PLANNING STAFF REPORT

MEMO DATE: February 11, 2022
MTG. DATE: **FEBRUARY 16, 2022**

RE: **Project Silver Eagle Precise Implementation Plan**

Figure 1: Additional Tree Line Recommendations

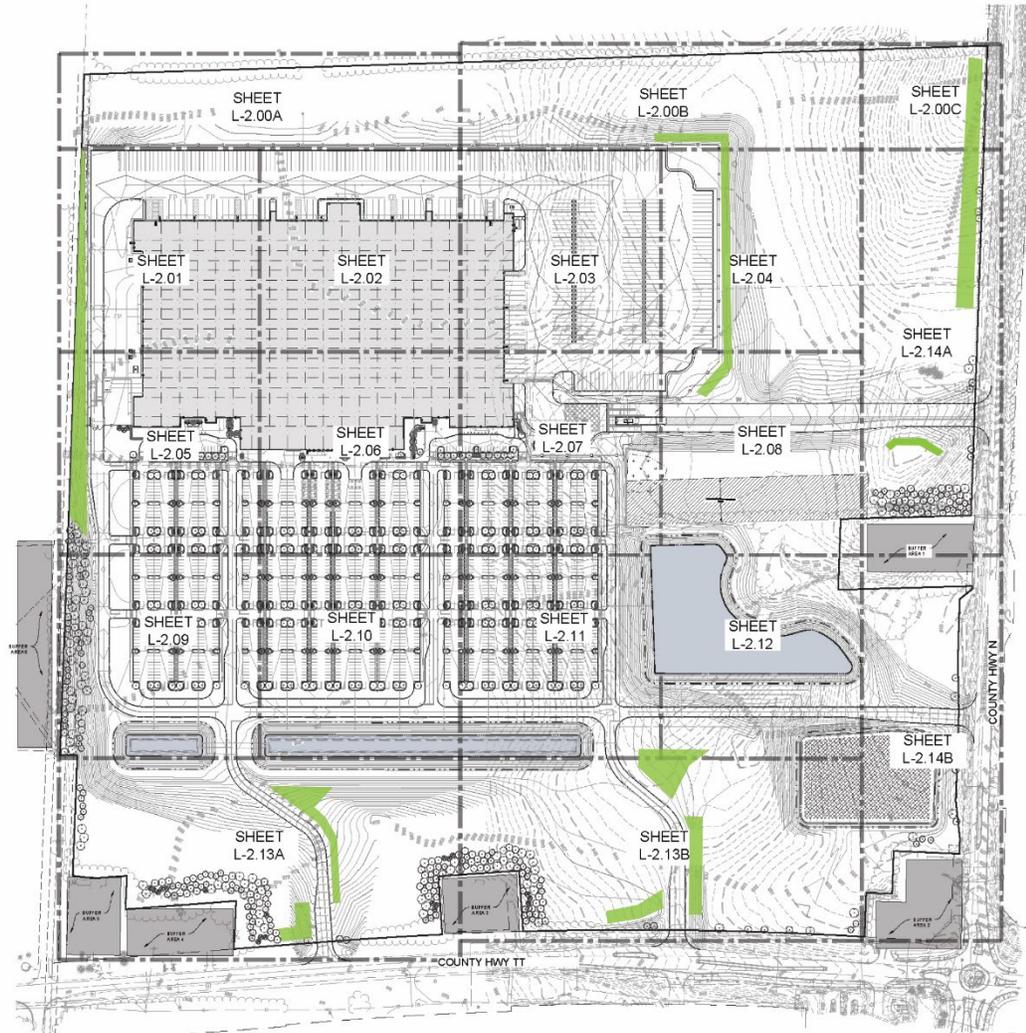
- “In situations where industrial uses abut non-industrial uses, screening should be provided.” *The submitted landscaping plan shows a ‘residential landscaping buffer’ adjacent to residentially zoned properties. Given the relationship of the proposed building relative to the adjacent neighborhood, staff recommends requiring the applicant to extend the buffer north along the west property line to at least the northern end of the fenced loading area. Additional buffer should be provided at the northeast corner of the loading area due to a gap in the existing tree line to the north of that location. See Figure 1 below for locations.*

- “Vehicles servicing the site should be able to move from one area of the site to another without re-entering a public street.” The vehicular circulation system shown on the site plan permits internal movement around the site and separates delivery trucks from employee vehicles.
- “Loading areas for industrial uses should be located at the rear of buildings and should be screened from the view of public rights of way and adjacent non-industrial uses.” The larger, primary loading area is located along the north (rear) of the building. A smaller loading area is located along the east side. Staff recommends requiring additional screening at areas shown on Figure 1 below.

5. To improve screening as described by the Comprehensive Plan, the applicant shall add tree plantings in areas shown in green on Figure 1, unless landscaping at such locations conflicts with the approved noise mitigation plan described above. These shall consist primarily of large conifers with some climax deciduous species.
